Office Action Summary	Application No. 10/552,532	Applicant(s) HAYASHI, YASUSHI	
	Examiner AMENE S. BAYOU	Art Unit 3746

DETAILED ACTION

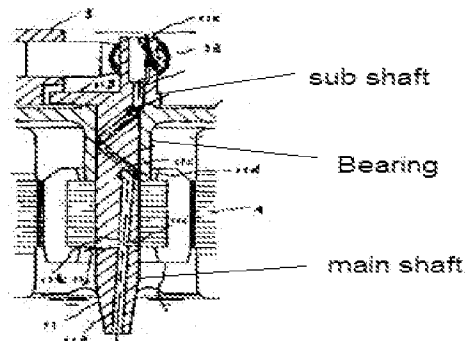
- Electric compressor ,in figure 1 and 2 ,comprising :a single phase induction motor (4) formed of stator and rotor
- A compressing mechanism (5) driven by the motor (4)
- A hermetic container (2) for accommodating the motor (4) and the compressing mechanism (2) and for pooling lubricant (7)
- A shaft having a main shaft and sub shaft (shown below)

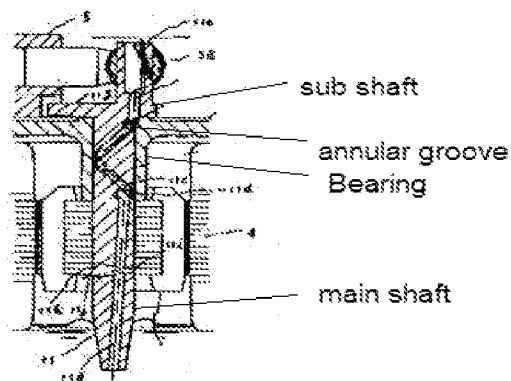
- A cylinder (5) for forming a compressing chamber
- A bearing (shown below) for supporting the main shaft

- A centrifugal pump (11) opening into the lubricant (7)
- A forward leading groove (11c) engraved on an outer wall of the main shaft and having a first end communicating with the centrifugal pump (11a) and a second end communicating with an annular lubricant groove (shown below) provided on an upper end of the bearing. Please also note that the applicant admitted the annular lubricant groove as prior art in page 1 line 24.

- A vertical hole (11f) bored in the sub shaft and having a first end communicating with the annular lubricant groove and a second end opening into the hermetic container .

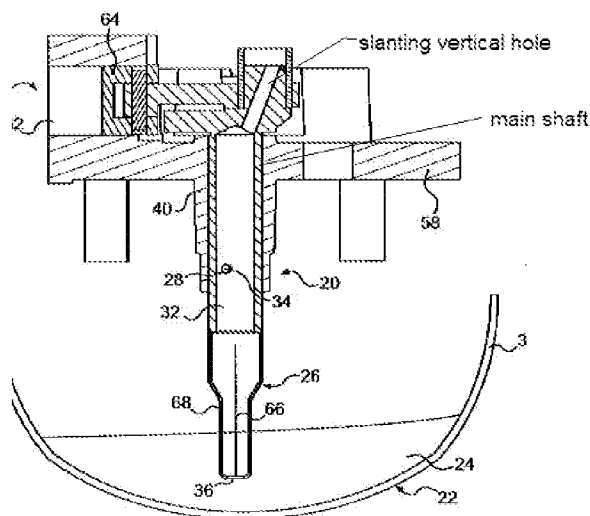
- A reverse leading groove (42) or having a lead directing in an opposite direction to that of the forward leading groove (42), in figure 7-9 and columns 3, line 39-50 and column 7, lines 7-11 .

- The reverse leading groove (42) of which first end communicates with the centrifugal pump (36) via a thinner section (46) of the shaft formed at the intermediate section of the shaft, in figure 6.
